UNITED STATES PATENT AND TRADEMARK OFFICE

Office Action Summary

10/695,158

DETAILED ACTION

Fig. 1
Related Art

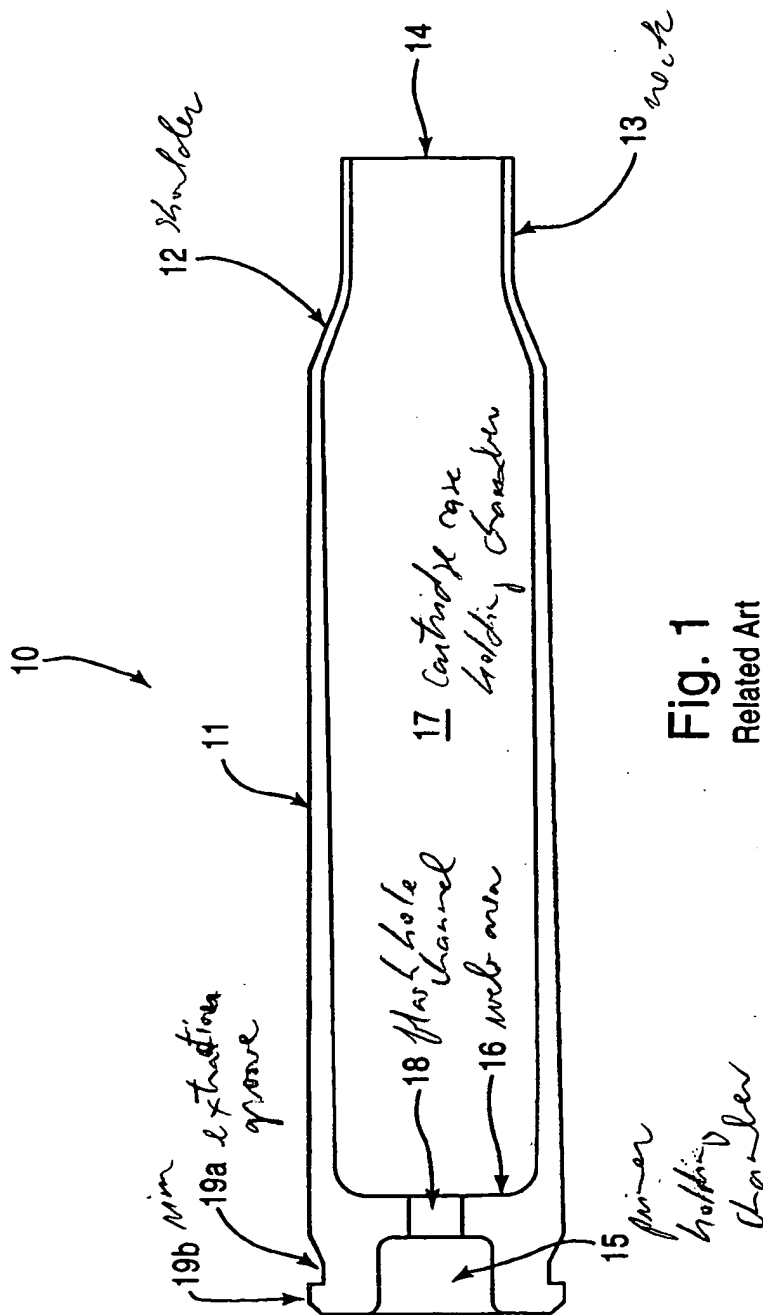
5. Claims 8-16 are rejected under 35 U.S.C. 103(a) as being unpatentable over Applicant's Admitted Prior Art (as set forth in Figures 1, 2, 3A, 3B, 4, 5, and paragraphs [0003] to [0028] in the specification; hereinafter is referred to as AAPA) in view of West et al. (US 5,616,642) (please see Figures 1, 2, 3A, and

AAPA discloses a lead-free cartridge case capable of holding a bullet having a cannellure formed along an outer circumferential surface of a body of the bullet, the cartridge case comprising:

- a cylindrical body having a front end and a rear end opposite the front end;
- a mouth defined by the front end of the body;

- engaging means for engaging the bullet, the engaging means being disposed along a perimeter of the mouth;

- a groove formed along an outer circumferential surface of the body in a vicinity of the rear end of the body;

- a web extending radially inward relative to the body and disposed intermediate the groove and the mouth, wherein the web separates a bullet holding chamber located on a front end side of the web from a primer holding chamber located on a rear end side of the web; and

- walls of the body which define the bullet holding chamber and are bendable in a direction toward and away from a longitudinal axis of the body, wherein the engaging means are configured to snap fit the cannellure of the bullet.

Fig. 2
Related Art

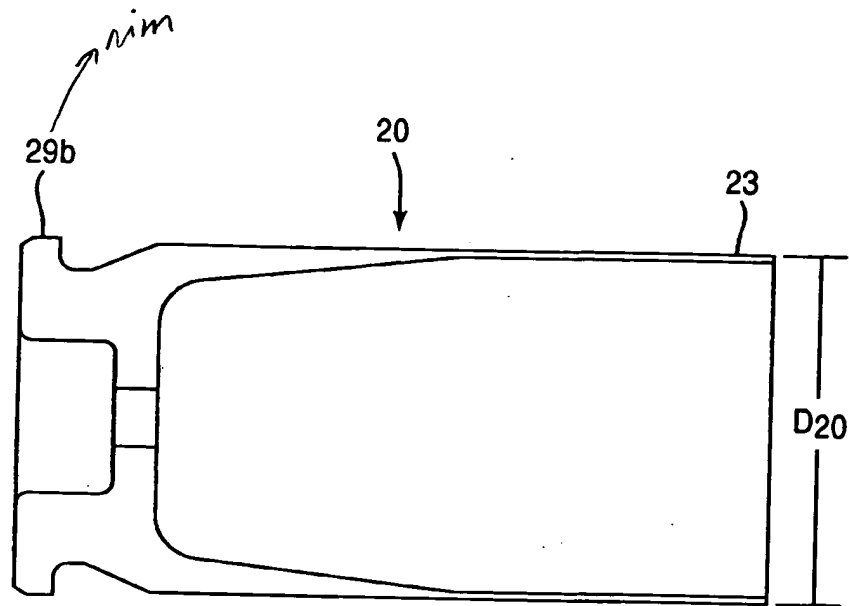
For claim 9, AAPA further discloses the walls defining the bullet holding chamber include tapered walls arranged oblique relative to the longitudinal axis of the body and straight walls arranged parallel relative to the longitudinal axis of the body, wherein the tapered walls taper away from the longitudinal axis of the body in a direction from the rear end to the front end of the body and transition to the straight walls at a blend point.

For claim 10, AAPA further discloses the engaging means include a lip lock having either one of an asymmetrical configuration or a symmetrical configuration.

For claim 11, AAPA further discloses the lip lock includes a base portion parallel relative to the longitudinal axis of the body and coinciding with the outer surface of the body, a tapered portion arranged oblique relative to the

longitudinal axis of the body, and an engaging portion, wherein the engaging portion is configured to fit within the cannellure of the bullet.

For claim 12, AAPA further discloses the engaging portion is either one of parallel or oblique relative to the base portion.
